# Delmore Fast-Track

25/06/2025 – Auckland Council Response

**Annexure 29:**

**Urban Design**

*Figure 1: Example of Elevated Lot and Retaining Wall Interface with Public Road. (Lots 760-763)*

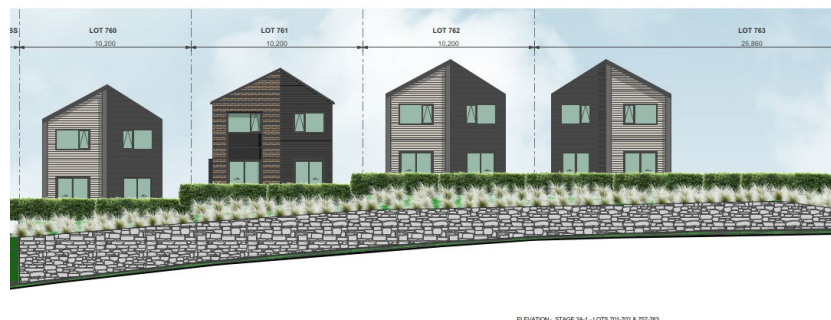
**40.** On the other hand, there are various instances where the road levels are notably different from the proposed lots. This results in some building blocks forming tall retaining walls along the public roads, and not allowing access and interaction between the public roads and the proposed lots. While these examples are not as common as the positive street arrangements, which are more common within the development with units designed more coherently with street levels, there are many instances where such a condition occurs. These examples are more common across parts of Stage 2 with more challenging topographical features. Some of them can be noted as:

- Lot 637 (A-S2-2-07, Appendix 15-20)
- Lots 703-707 (A-S2-2-14, Appendix 15-20)
- Lots 710-711 (A-S2-2-16, Appendix 15-20)
- Lots 701-702 and Lots 757-763 (A-S2-2-20, Appendix 15-20)
- Lot 845 (A-S2-2-24, Appendix 15-21)
- Lots 948-951 (A-S2-2-32, Appendix 15-21)
- Lots 888-892 (A-S2-2-33, Appendix 15-21)
- Lots 918 (A-S2-2-36, Appendix 15-21)
- Lots 1024-1026 (A-S2-2-45, Appendix 15-23)
- Lots 1128-1132 (A-S2-2- 46, appendix 15-23)
- Lots 1081-1086 (A-S2-2- 48, appendix 15-23)

**41.** While the presence of tall retaining walls and limited direct lot-street interfaces is not an ideal outcome from a streetscape and accessibility perspective, these instances are primarily confined to more topographically constrained parts of the site. Although these conditions represent a minority of the overall development layout, they should still be acknowledged as a concern. The affected locations detract from the local interface quality and may reduce the overall legibility and permeability of the street network in these areas. They appear to be a localised design compromise in response to site-specific constraints. Further clarification has
